**Town of Kittery  
 Planning Board Meeting  
 April 11, 2019**

**ITEM 2 - Huntington Run Cluster Subdivision – Major Modification to an Approved Subdivision Plan**

**RE: Town of Kittery, Planning Board Services  
Huntington Run Cluster Subdivision; 40 Betty Welch Road, Tax Map 66, Lots 2A, 8, & 8A  
Review #3. CMA #591.108**

## EXHIBIT- A

TITLE:

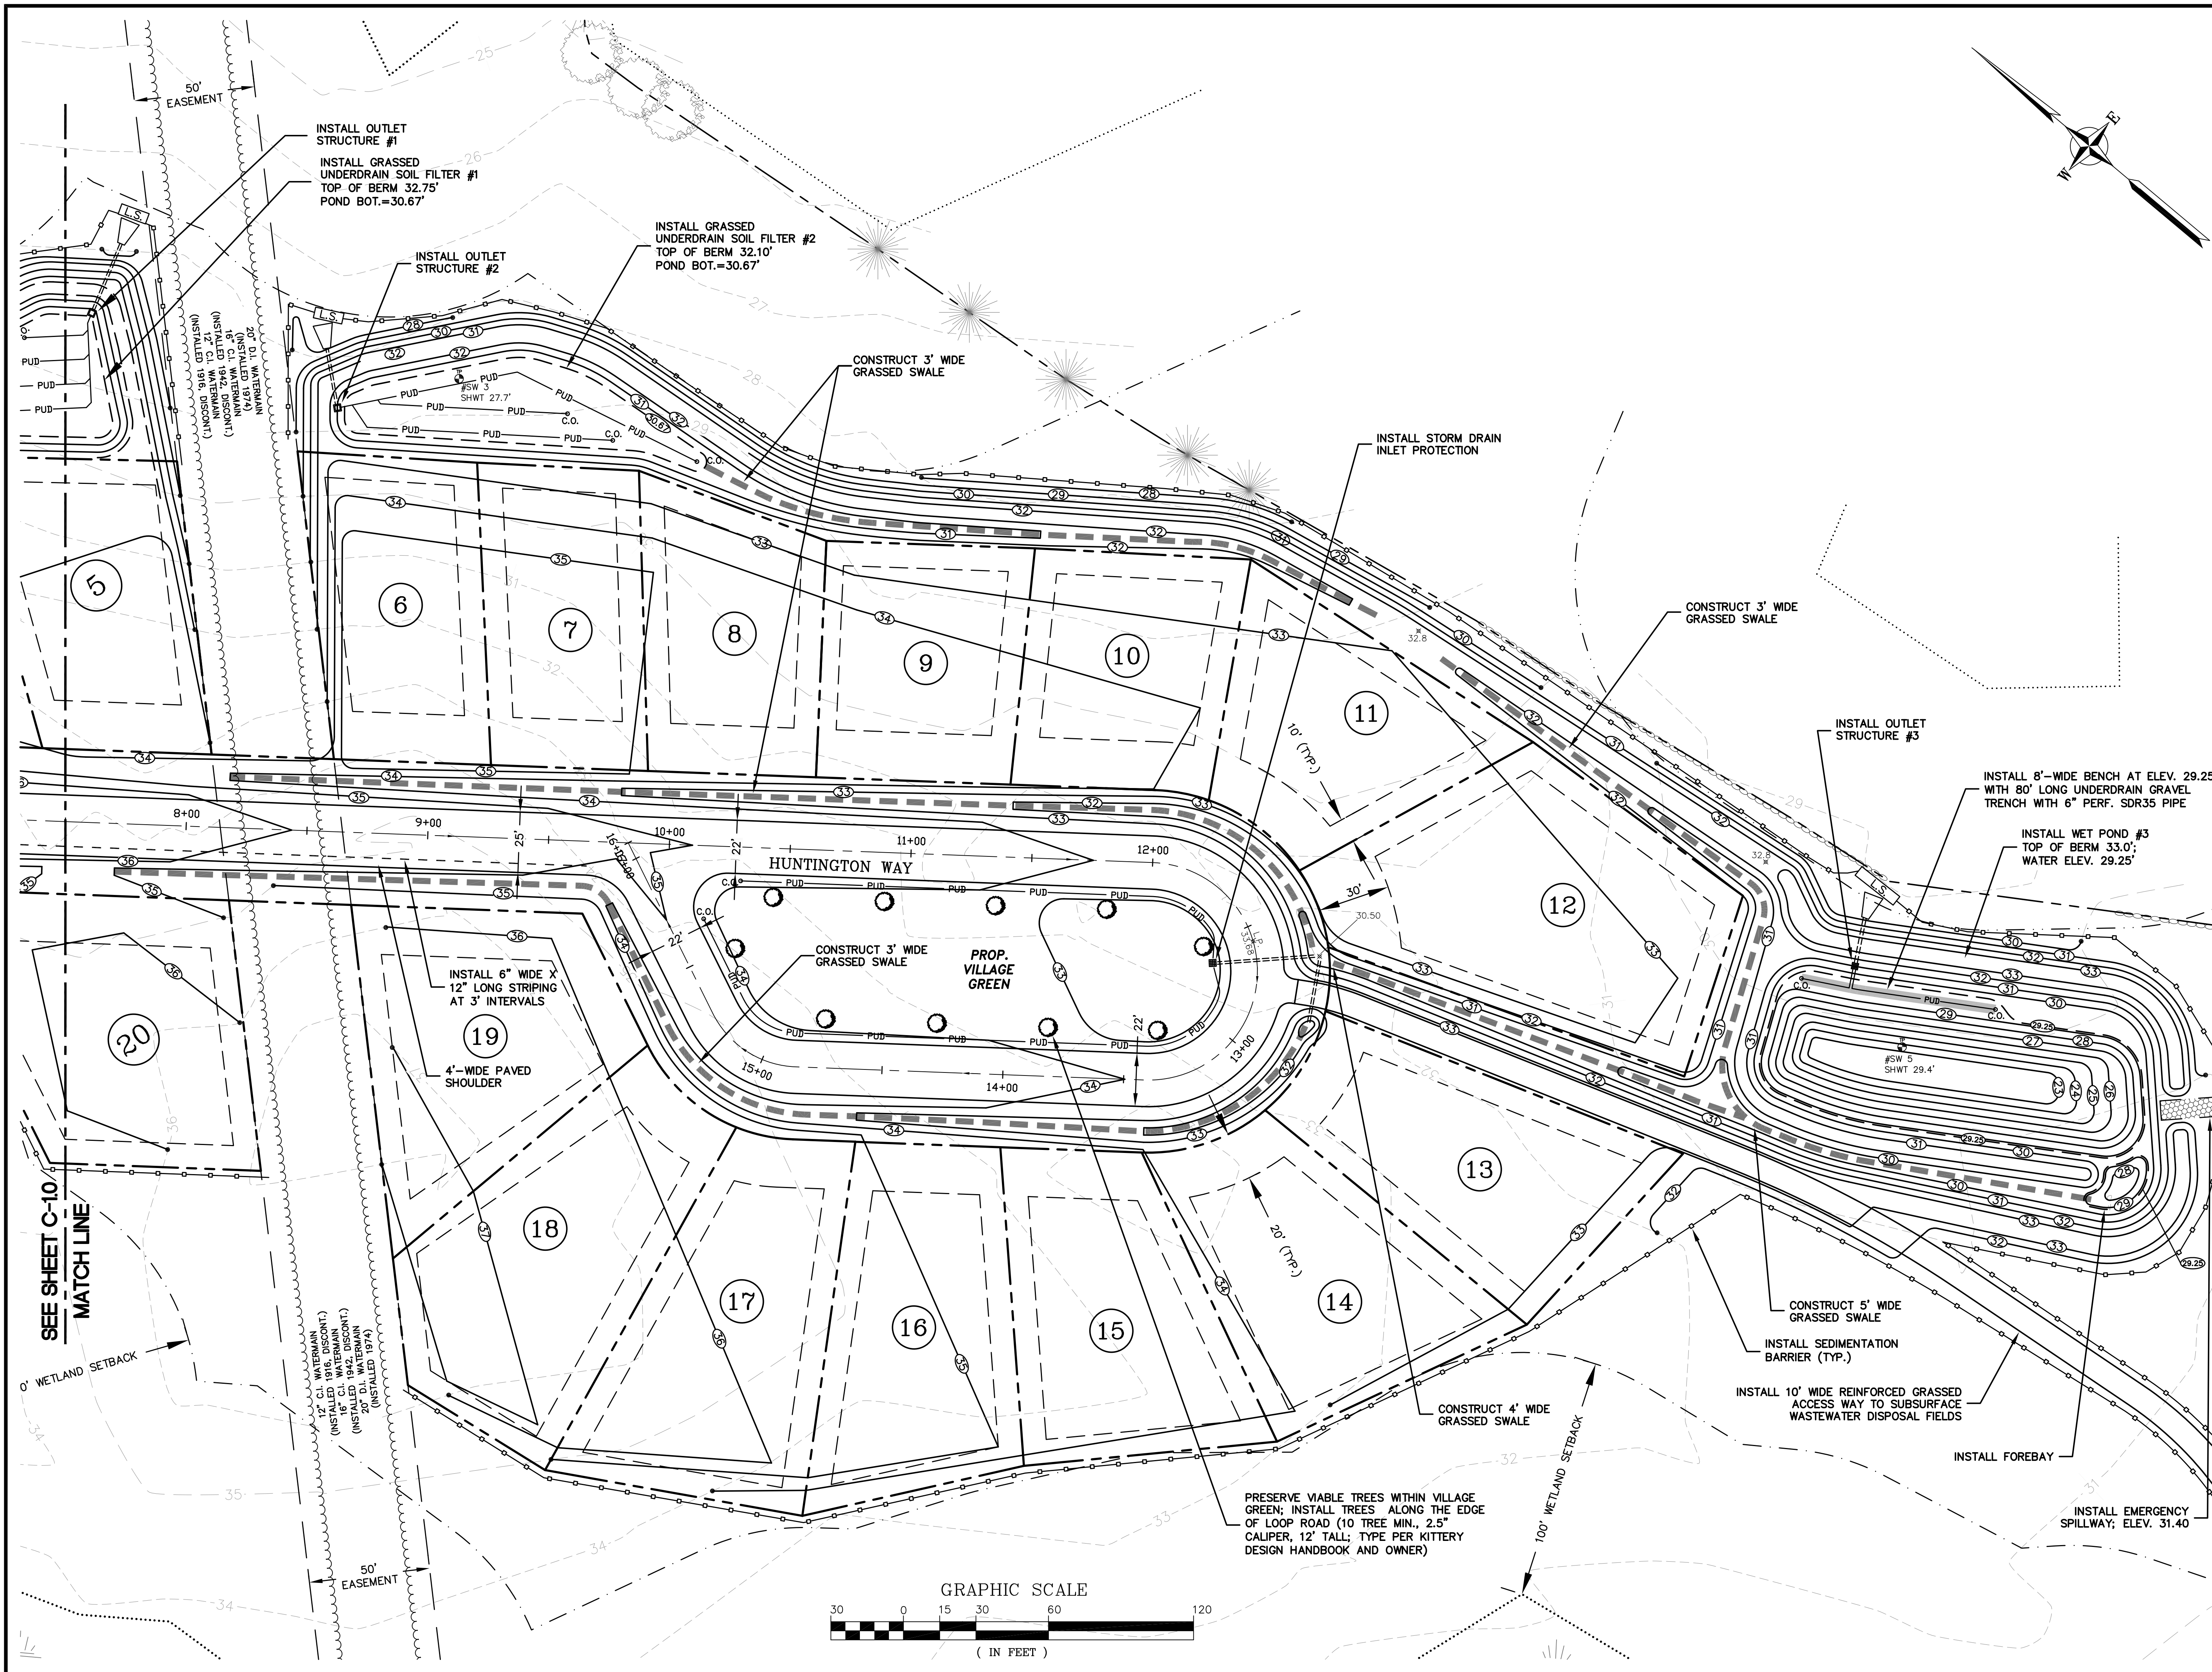
Here are the roadway plans that have the hydrant locations. There is the existing one on Betty Welch Road at the entrance and the new one in the cul-de-sac loop. They are not changing with this modification.

The Kittery Planning Board voted to approve the final plan for the Huntington Run Cluster Subdivision project at their March 14, 2019 meeting. On behalf of the applicant and owner, Chinburg Development, LLC, we respectfully submit the enclosed *Major Modification to an Approved Site Plan Application* to amend the approved plan by providing a 4 foot wide paved shoulder on the south side of Huntington Way from its intersection with Betty Welch Road to the beginning of the cul-de-sac loop (adjacent to Lot 19). All other roadway shoulders are proposed as 1 foot of pavement with gravel shoulders of varying width as depicted on the plans. The proposal requires a waiver from Section 16.8.4.4 and Table 1 Private Streets Standard – Street Width Design d. Paved Shoulder.

NO.	DESCRIPTION	BY	DATE
0	PB SUBMISSION	JKC	6/22/17
1	MDEP SUBMISSION	JKC	3/19/18
2	REVISED ROADWAY WIDTH	JKC	8/23/18
3	TOWN FINAL APPROVAL	JKC	1/24/19
4	ADD WALKWAY	JKC	3/21/19

**TYPICAL ROADWAY CROSS SECTION**  
STA. 0+10 TO STA. 9+80  
NOT TO SCALE

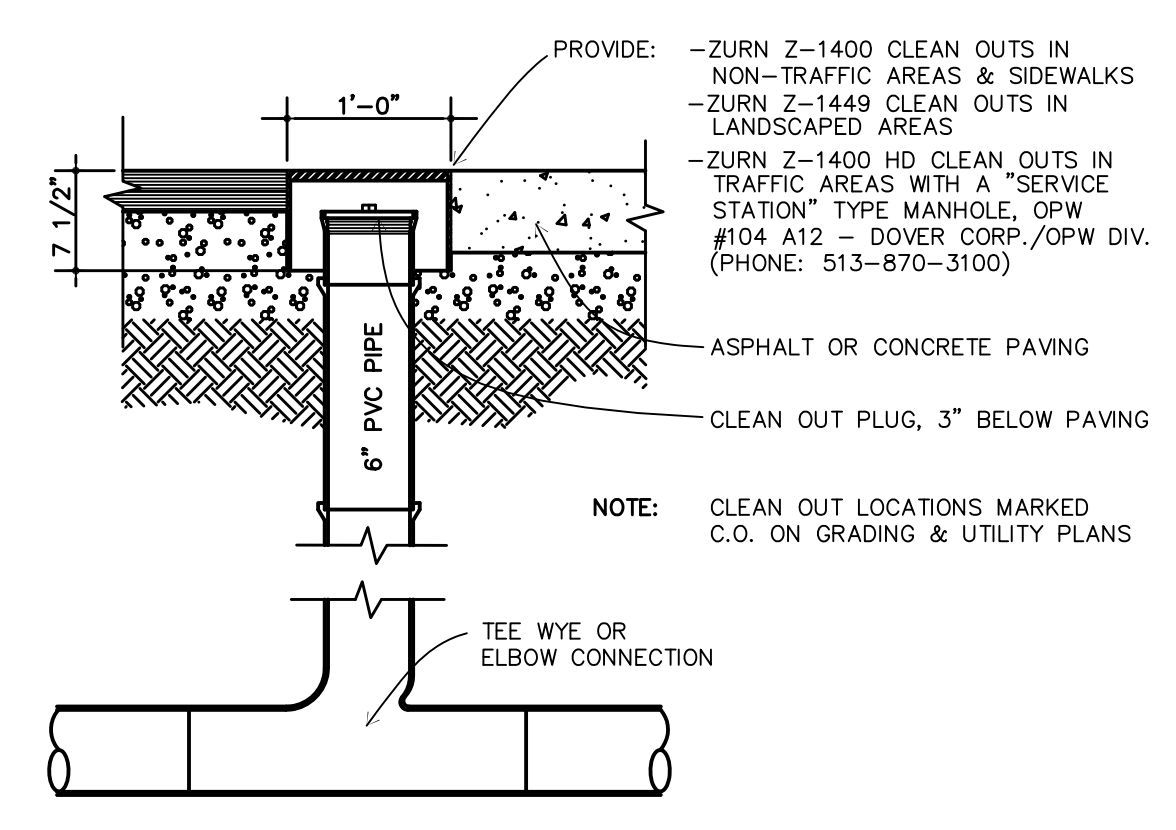
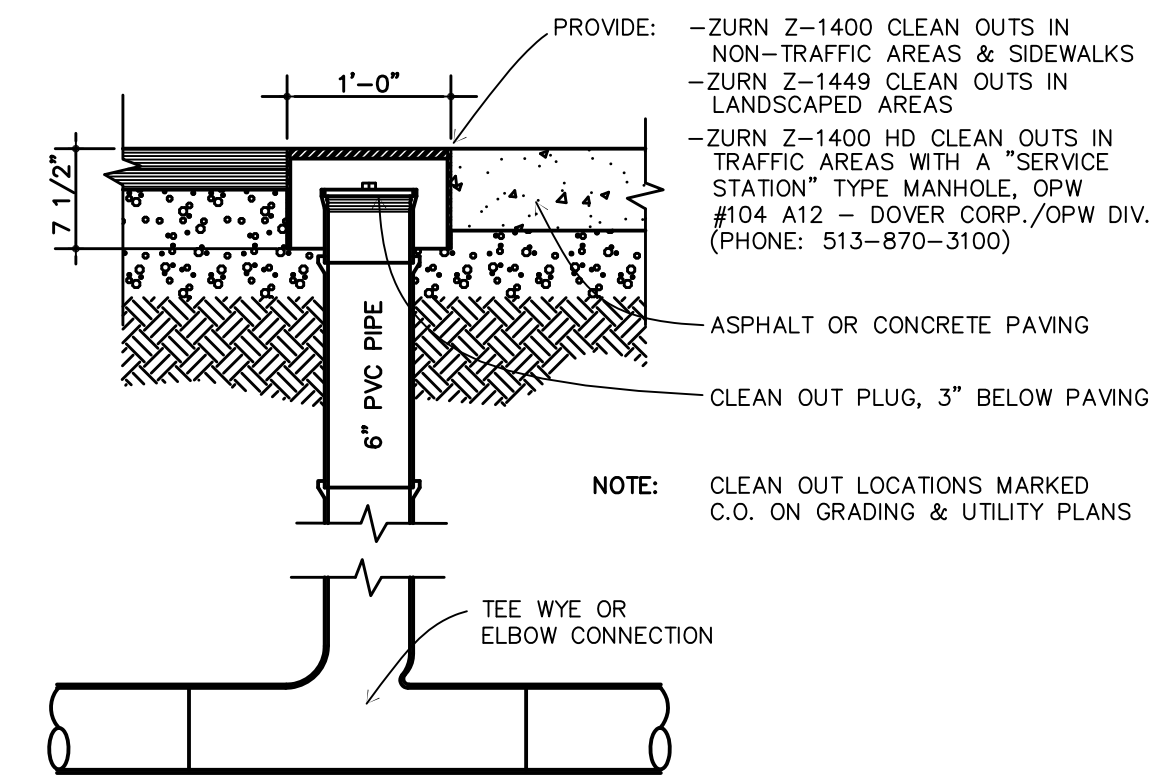
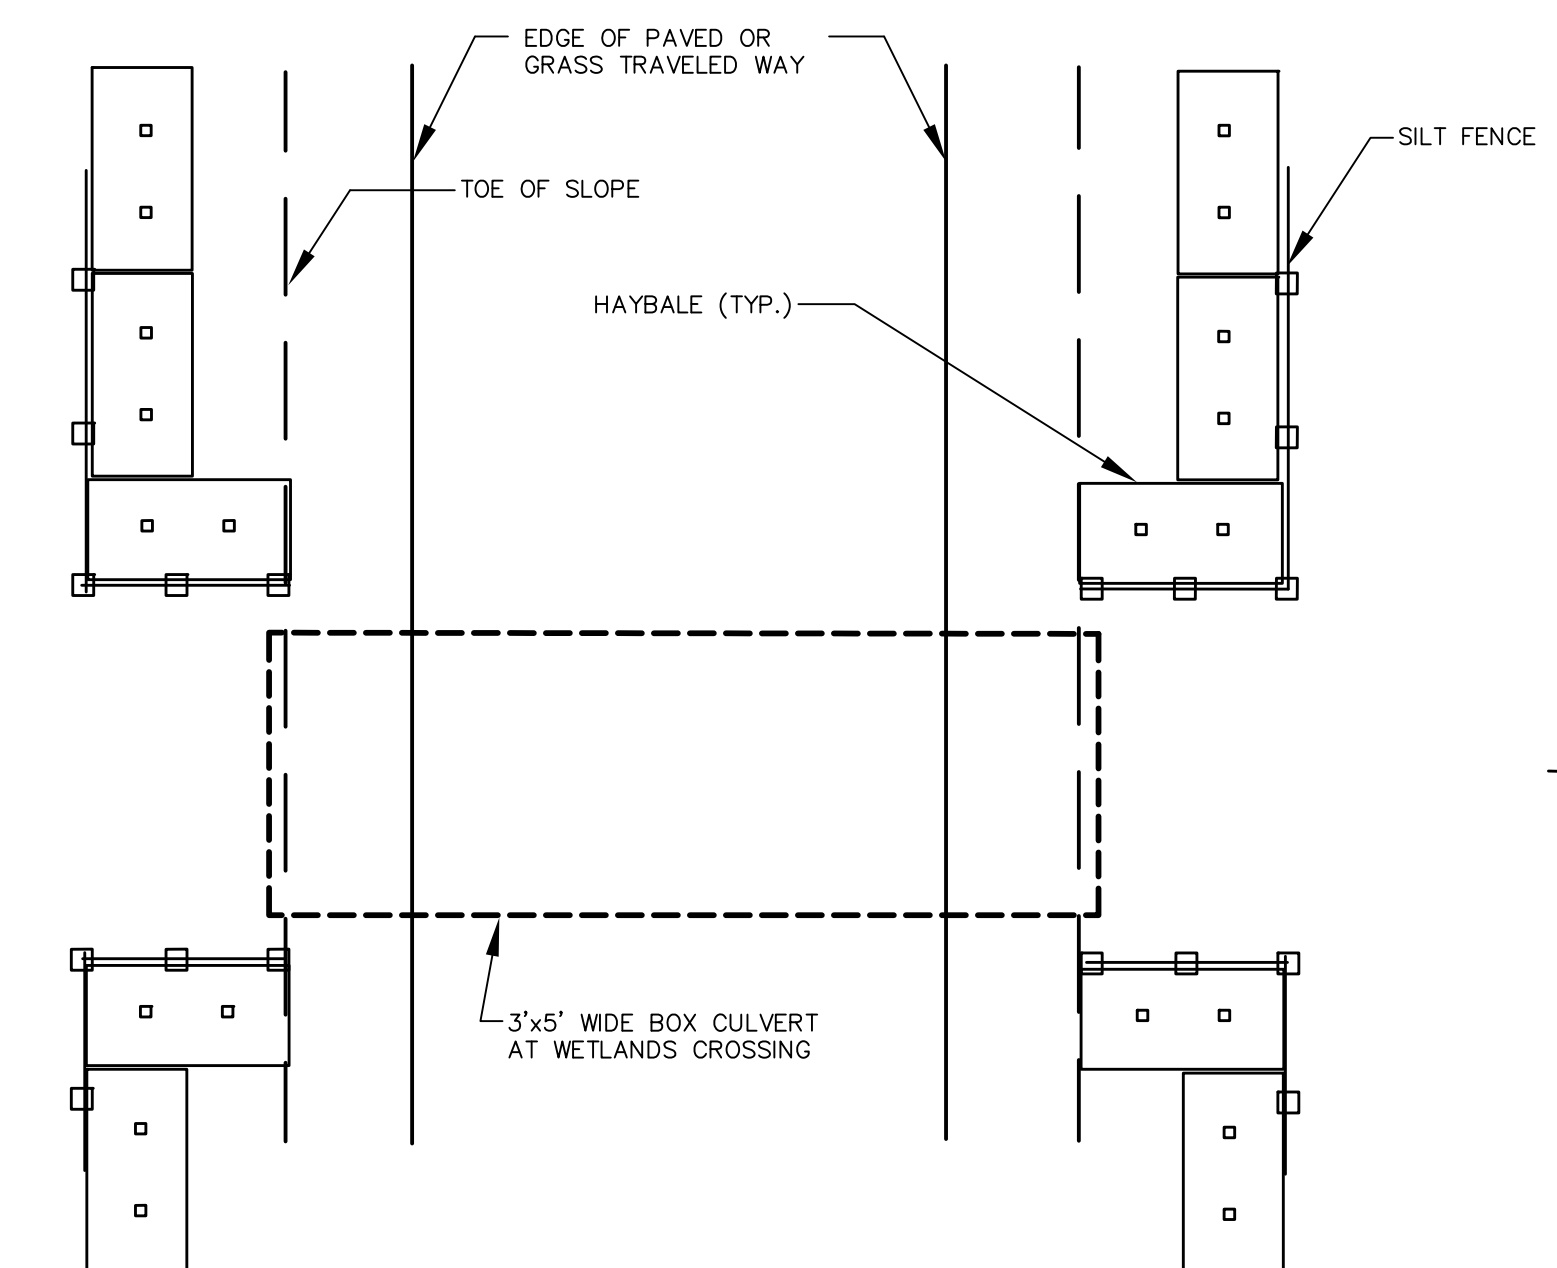
The current application includes paved shoulders on both sides of the road, in addition to the paved travel way (10' lanes). We concur with that design as it is consistent with the recommendation we made in our previous reviews of the project regarding paved shoulders. On one side (north side), the paved shoulder is 1 -ft. wide, with an additional 2-feet of gravel shoulder. On the other side (south side) a 4-foot paved shoulder is proposed as a separate pedestrian way, with an additional 1-foot gravel shoulder. The total roadway with remains 28 feet. The 4-foot paved shoulder is proposed to be demarcated with a dashed white line, to separate pedestrians from vehicles.

At the March 14, 2019 Kittery Planning Board meeting, the applicant presented a waiver request from Section 16.8.4.4(d) of the Land Use and Development Code (LUDC) street standards. The proposal was to provide 1-foot wide paved shoulders in lieu of the 2-foot and 8-foot wide paved shoulders listed in Table 1, standards for Minor Streets, under *d. Paved Shoulder*. The Planning Board did not approve the waiver request as presented. In particular, Board members cited safety concerns about children traveling along Huntington Way to the school bus stop at Betty Welch Road. To address this concern, the applicant now proposes a 4-foot wide paved shoulder on the south side of Huntington Way from Betty Welch Road to the beginning of the cul-de-sac loop (adjacent to Lot 19), a distance of 935 feet. Striping will delineate the paved shoulder from the travelled way. With the 20-foot travelled way, the overall pavement width along this section of Huntington Way will be 25 feet. All other roadway shoulders are proposed to be constructed as 1-foot of pavement and gravel shoulders of varying width as depicted on the plans.

NO.	DESCRIPTION	BY	DATE
0	PB SUBMISSION	JKC	6/22/17
1	MDEP SUBMISSION	JKC	3/19/18
2	REVISED ROADWAY X-SEC	JKC	8/23/18
3	TOWN FINAL APPROVAL	JKC	1/24/19
4	REVISE ROAD X-SECTION	JKC	3/21/19
